ADDENDUM NO. 1

March 30, 2026

OLIN HALL
ACCESSIBLE ROUTE AND PARKING

6 **SIDEWALK OVER RETAINING WALL DETAIL**
 SCALE: 3/4" = 1'-0"

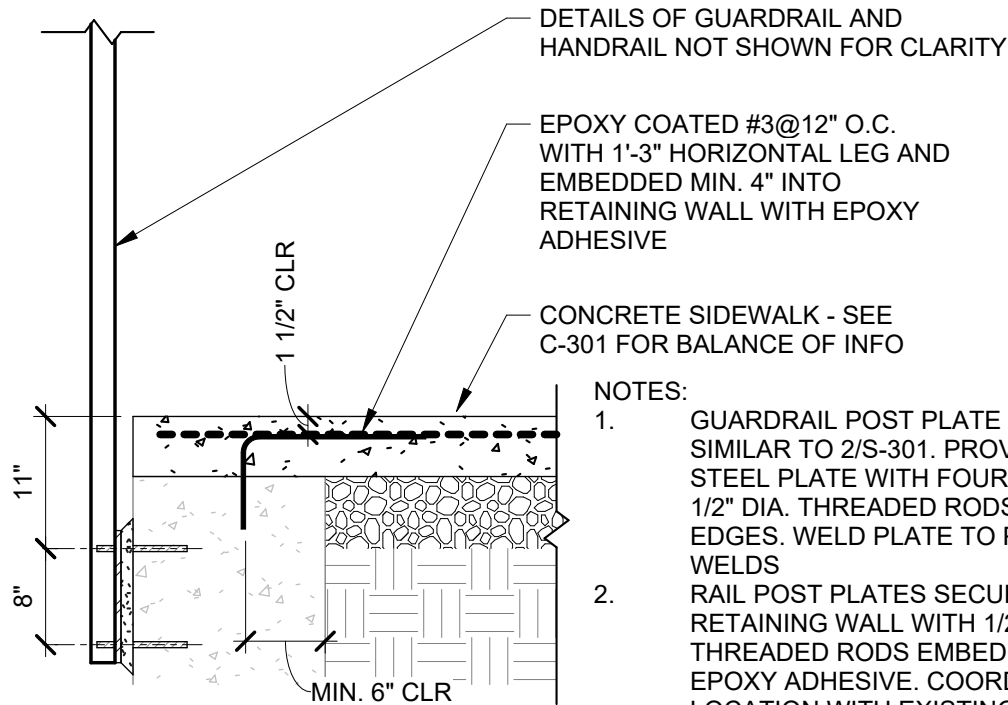
Item 4. **ADD** Sketch SSK-01 "6 / S-301 SIDEWALK OVER RETAINING WALL DETAIL", attached.

1. GUARDRAIL POST PLATE ATTACHMENT SIMILAR TO 2/S-301. PROVIDE 11" X 11" X 1/2" STEEL PLATE WITH FOUR (4) HOLES FOR 1/2" DIA. THREADED RODS 1-1/2" FROM EDGES. WELD PLATE TO POST WITH 3/16" WELDS
2. RAIL POST PLATES SECURED TO EXISTING RETAINING WALL WITH 1/2" DIA. SS THREADED RODS EMBEDDED 4-1/2" WITH EPOXY ADHESIVE. COORDINATE ANCHOR LOCATION WITH EXISTING REINFORCEMENT
3. PROVIDE 1" NONSHRINK GROUT BETWEEN PLATE AND FACE OF RETAINING WALL

7 / S-301 NEW CONCRETE WALL CAP
DETAIL

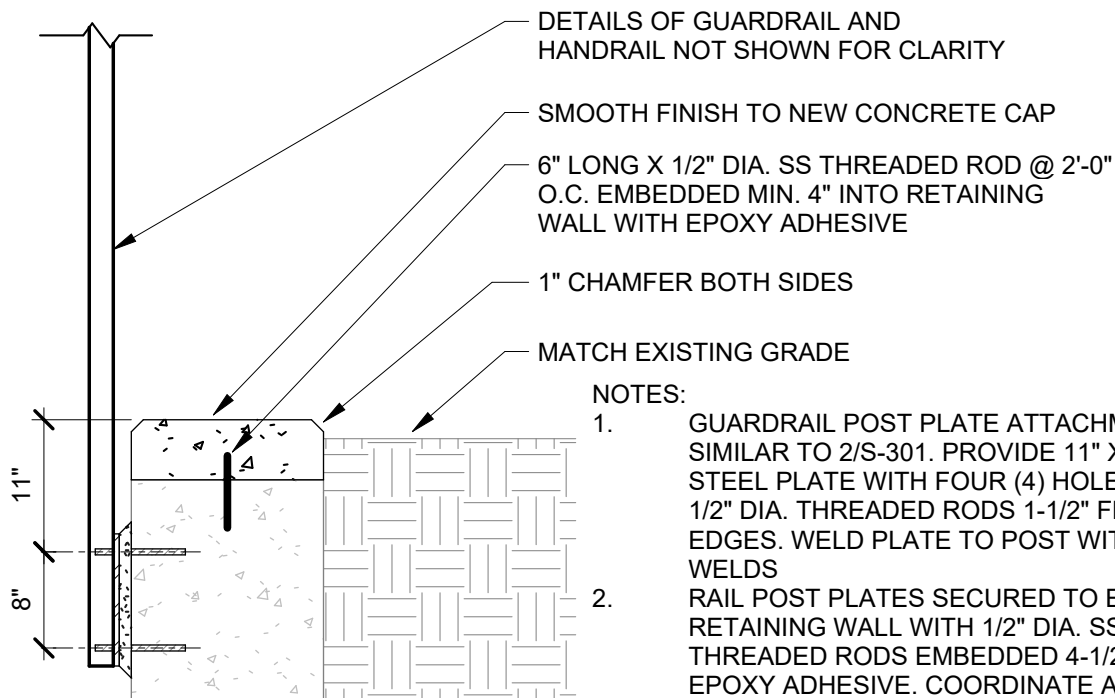
Item 5. **ADD** Sketch SSK-02 "7 / S-301 NEW CONCRETE WALL CAP DETAIL", attached.

1. GUARDRAIL POST PLATE ATTACHMENT SIMILAR TO 2/S-301. PROVIDE 11" X 11" X 1/2" STEEL PLATE WITH FOUR (4) HOLES FOR 1/2" DIA. THREADED RODS 1-1/2" FROM EDGES. WELD PLATE TO POST WITH 3/16" WELDS
2. RAIL POST PLATES SECURED TO EXISTING RETAINING WALL WITH 1/2" DIA. SS THREADED RODS EMBEDDED 4-1/2" WITH EPOXY ADHESIVE. COORDINATE ANCHOR LOCATION WITH EXISTING REINFORCEMENT
3. PROVIDE 1" NONSHRINK GROUT BETWEEN PLATE AND FACE OF RETAINING WALL

6 GRILLAGE BEAM AT END OF METAL RAMP DETAIL
 SCALE: 1" = 1'-0"

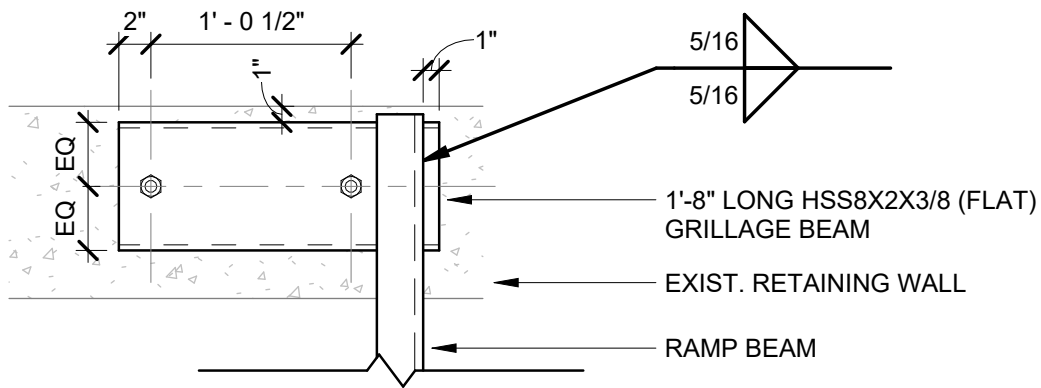
Item 7. **ADD** Sketch SKK-03 "6 / S-302 GRILLAGE BEAM AT END OF METAL RAMP
DETAIL", attached.

1. WEST RAMP BEAM IS OPPOSITE DETAIL
2. PROVIDE 2" NONSHIRNK GROUT BENEATH GRILLAGE BEAM
3. PROVIDE TWO (2) 3/4" DIA. SS THREADED RODS EMBEDDED 4-1/2" INTO EXISTING WALL WITH EPOXY ADHESIVE. INSTALL SIMILAR TO ANCHOR ROD DETAIL.

7 / S-302 BRACED FRAME DIMENSION
DIAGRAM

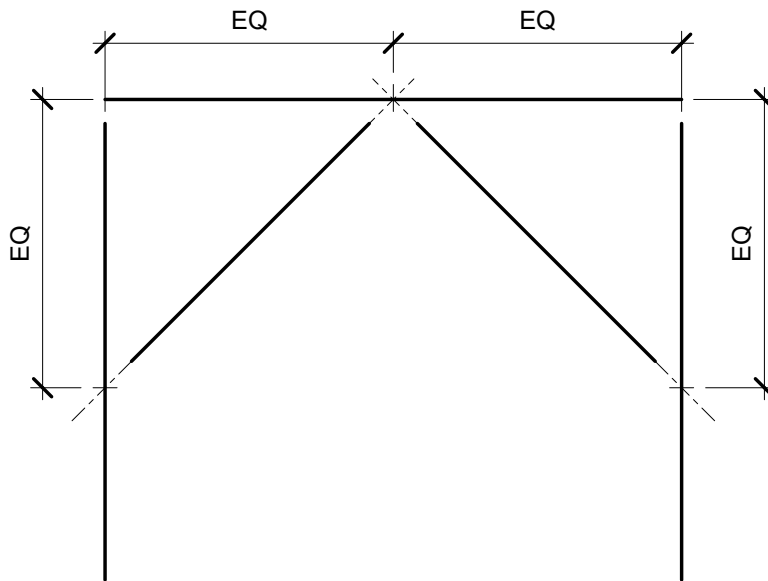
Item 8. **ADD** Sketch SSK-04 "7 / S-302 BRACED FRAME DIMENSION DIAGRAM", attached.

1 LONGITUDINAL CONCRETE RAMP SECTION
SCALE: 3/4" = 1'-0"

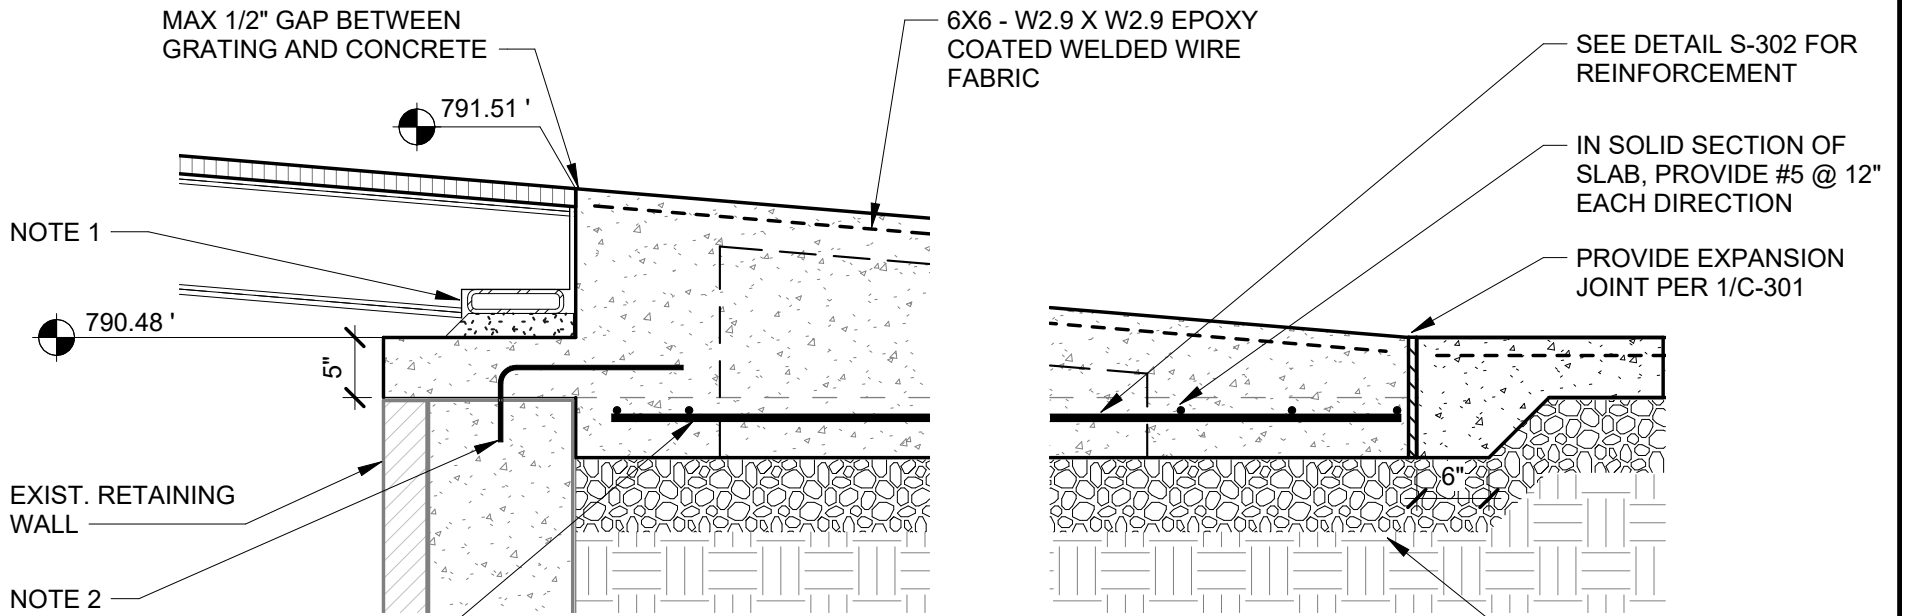
DELETE Detail 1 "LONGITUDINAL CONCRETE RAMP SECTION", in its entirety.

Item 10. **ADD** Sketch SSK-05 "1 / S-303 LONGITUDINAL CONCRETE RAMP SECTION",
attached.

1. PRIOR TO GALVANIZING, CUT BOTTOM OF CHANNELS AT AN ANGLE MATCHING THE SLOPE OF THE RAMP. PROVIDE GRILLAGE BEAM AT EACH CHANNEL. SEE DETAIL 6/S-302.
2. #3 DOWELS @ 12" O.C. CENTERED IN DEPTH OF NEW CONCRETE WALL CAP AND EMBEDDED MIN. 3-1/2" IN CENTER OF EXISTING WALL WITH EPOXY ADHESIVE. DOWEL SHALL HAVE ONE LEG 6" AND ONE LEG 1'-3"
